**EXPLANATION OF SIGNIFICANT DIFFERENCES
FOR THE 300-FF-2 OPERABLE UNIT RECORD OF DECISION**

May 2004

USDOE Hanford 300 Area
300-FF-2 Operable Unit
Hanford Site
Benton County, Washington

Figure 1. 300 Area Waste Site Groups Identified for Unrestricted Use Cleanup.

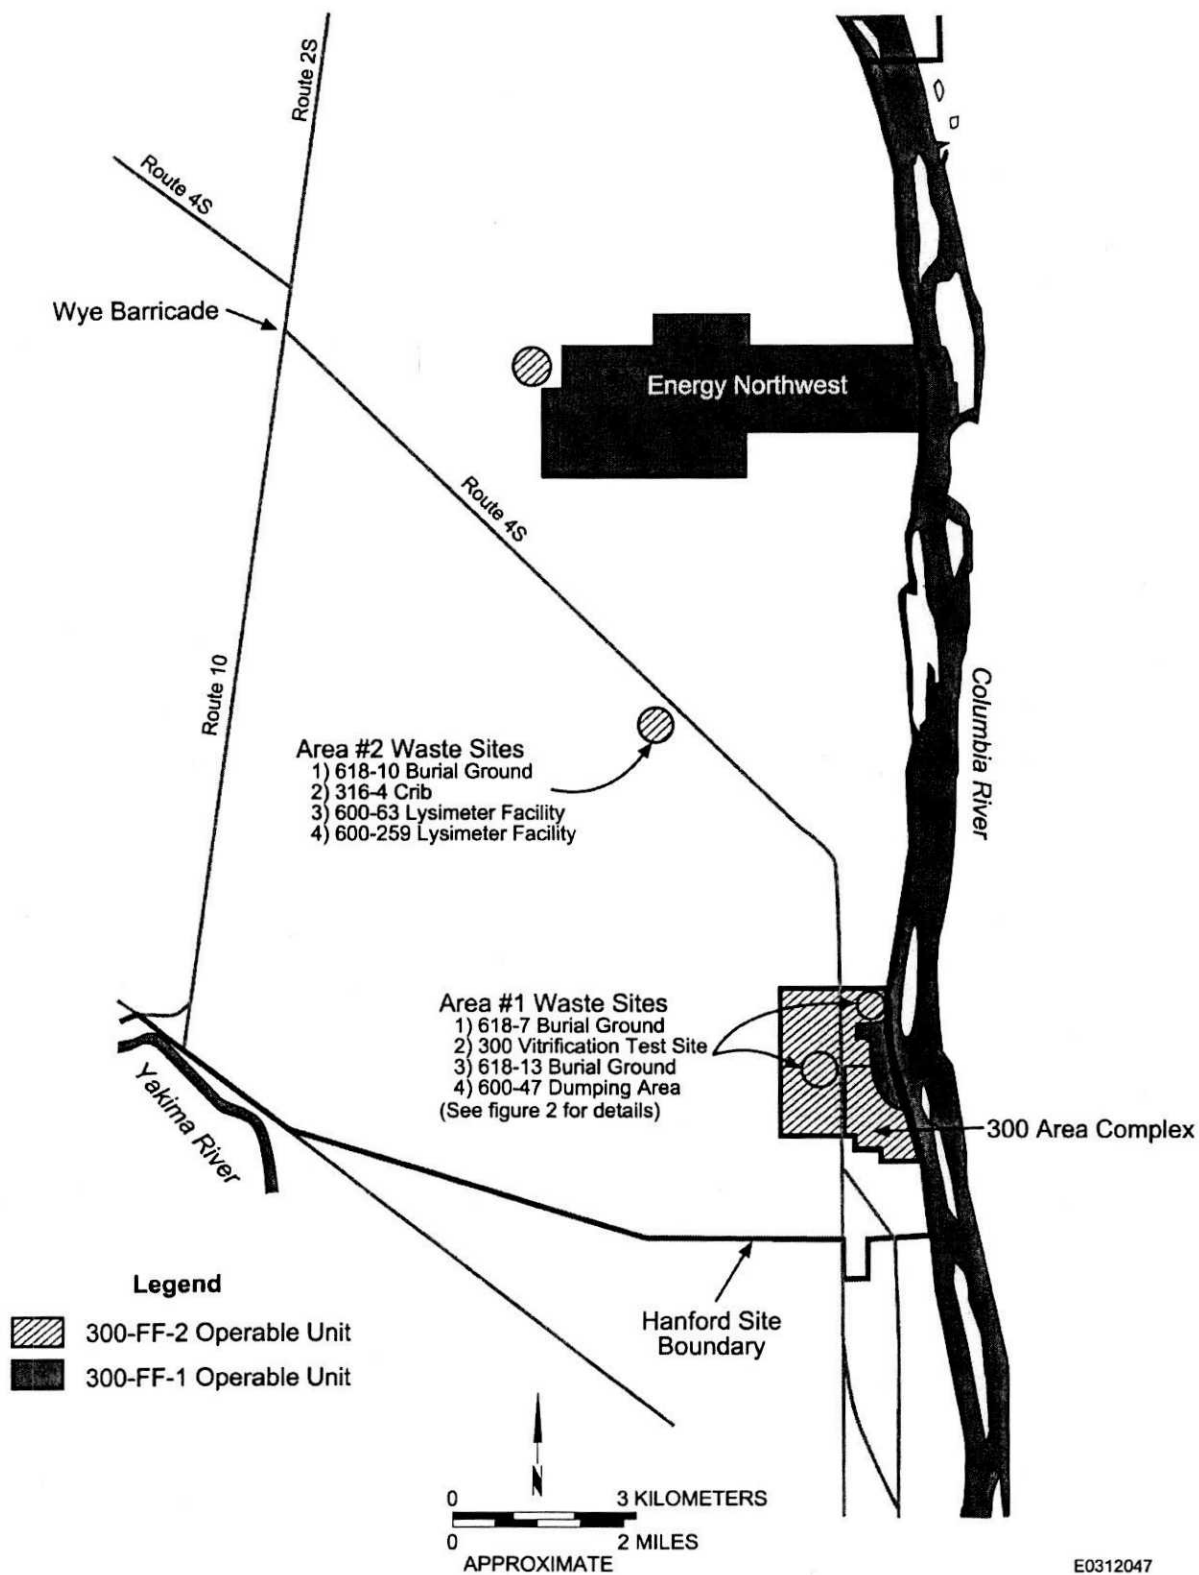
Change 2: Modify the soil cleanup levels for eight outlying waste sites. The 300-FF-2 ROD concluded that the reasonably anticipated future land use would be industrial for the entire 300-FF-2 Operable Unit (OU), which was based on available land-use planning documents and was the basis for the industrial cleanup levels. Further evaluation by the Tri-Parties concluded that a change in cleanup levels would be appropriate for eight specific outlying waste sites in order to reduce the long term costs of institutional controls and allow other beneficial uses of these outlying areas. The location of these waste sites is depicted in Figure 1 and Figure 2. The revised cleanup levels are based on the 100 Area rural residential exposure scenario, commonly referred to as unrestricted, and are listed in Tables 1 and 2.

In addition, the Tri-Parties have agreed that unrestricted use soil cleanup levels for eight waste sites would be appropriate in the 300-FF-2 OU, that are located outside the 300 Area "core industrial zone area" (see Figures 1 and 2). An ESD is necessary to change the cleanup levels for these eight specific outlying waste sites.

Change 2: Modify the soil cleanup levels for eight outlying waste sites.

The key assumptions in the 300 Area unrestricted land-use scenario that affect the groundwater protection determination are irrigation at agronomic rates (76 cm/yr [30 in./yr]), surface vegetation resulting in an evapotranspiration coefficient of 91%, and the change in the exposure pathway to include drinking water ingestion. Based on the unrestricted land-use scenario described above, the cleanup levels to be used for the eight waste sites are listed in Tables 1 and 2.

Figure 3. Solid Waste Uranium Groundwater Protection Assessment Model.

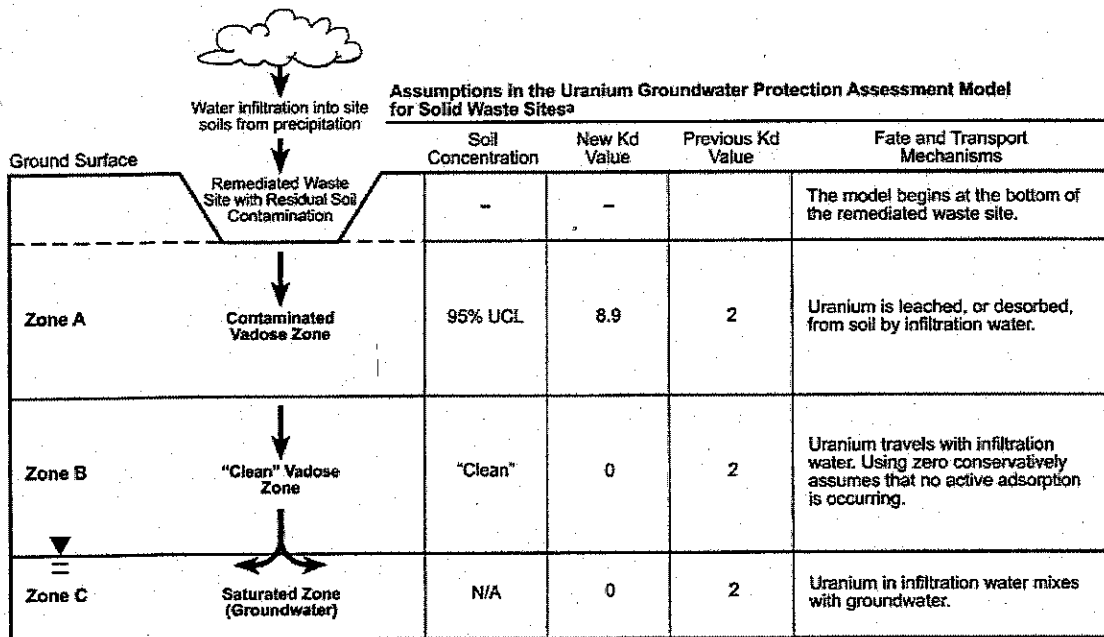
The most conservative K_d values of 8.9 mL/g for the desorption phase of the contaminated zone, and 0 mL/g for the adsorption phase of the uncontaminated zone and saturated zone respectively, were selected to be the K_d values used to assess the protectiveness of residual contamination following remediation.

A RESRAD assessment of site-specific residual uranium soil concentrations for groundwater protection was performed using new K_d values (8.9 mL/g for the contaminated zone, 0 mL/g for the uncontaminated zone, and 0 mL/g for the saturated zone). In addition, the approaches developed in the *Remedial Design Report/Remedial Action Work Plan for the 300 Area* (RDR/RAWP) (DOE-RL 2002b) for cleanup verification of solid and liquid waste disposal sites were also applied. The RESRAD calculations used the applicable land-use scenario (industrial, without irrigation), soil characteristics, and hydrogeologic inputs. The model calculated the concentrations in groundwater, and then these concentrations were compared to the drinking water standard maximum contaminant level (MCL) of 30 $\mu\text{g/L}$ (20.8 pCi/L) for making decisions on whether residual contamination levels are protective of groundwater. The model predicts that 267 pCi/g of uranium in soil is protective of groundwater at the drinking water MCL standard and of the Columbia River.

The old and the new conceptual models are shown in Figures 3 and 4.

^a In the groundwater protection assessment model for solid waste sites, an assumption is made that the upper 50% of the vadose zone beneath the excavated waste site (Zone A) is assumed to be contaminated (i.e., as a result of leaching) and the lower 50% (Zone B) is assumed to be clean. The concentration used for Zone A is the 95% Upper Confidence Limit (UCL) of the mean of cleanup verification samples collected from the bottom of the remediated site.
